# United States Patent and Trademark Office

APPLICATION 1	NO. F	ILING DATE	FIRST NAMED INVENTOR	ATTORNEY DOCKET NO.	CONFIRMATION NO.
10/723,064		11/26/2003	Baudry Jean-Pierre	0595-1038	8623
466	7590	02/07/2006		EXAMINER	
	3 & THOMI		HOLZEN, STEPHEN A		
745 SOU 2ND FLO	TH 23RD ST OOR	REET		ART UNIT PAPER NUMBER	
	TON, VA	22202	3644

#### **DETAILED ACTION**

Figure 1: Illustrating Examiners position regarding US Pub. 2003/0004619

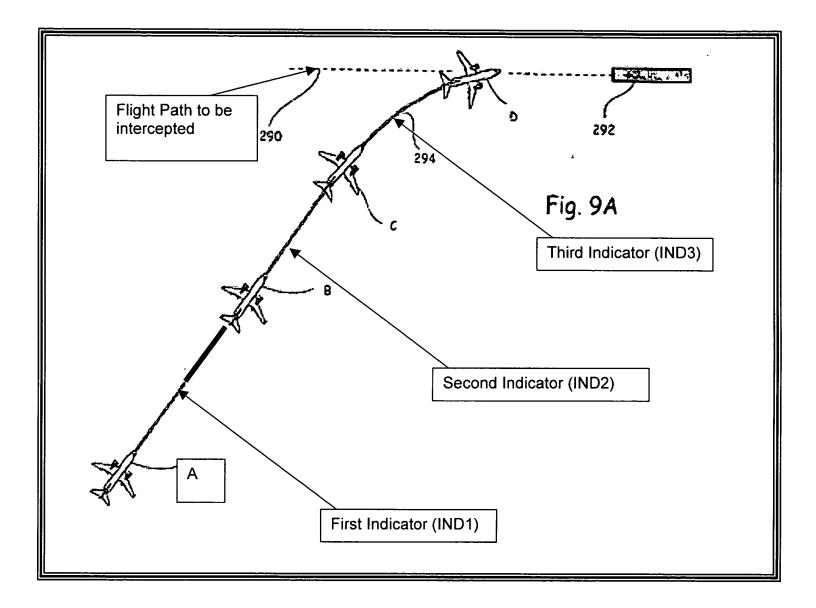
a first indicator (IND1, Figure 1 below) that is attached to said first symbol and that straight line with an angular orientation corresponding to a direction of the ground speed vector and with length is <u>capable of varying</u> and <u>capable of corresponding</u> to the magnitude of the ground speed vector when the magnitude exceeds a predetermined value and that is constant and proportional to the predetermined value when the magnitude less than or equal to the predetermined value,

second indicator (IND2) that is attached to said first indicator (see Figure 1 Below) and that a straight line whose direction is <u>capable of indicating</u> the initial part of an approach path for intercepting the flight path and whose length is <u>capable of adjusting</u> as the position the airplane changes relative to the flight path,

and third indicator (IND3) that extends tangentially from said second indicator and is connected tangentially to flight path, said third indicator being a curved indicating a final part of the approach path for intercepting the flight path (see Figure 1 Below).

Re – Claim 64: Necessarily the curve (IND3) represents a flight path that is capable of being achieved. The examiner asserts that the calculating step 310 generates the optimal course and the schematic diagram illustrates this course based on the current flight characteristic (airspeed, turning capability, wind speed and direction.)
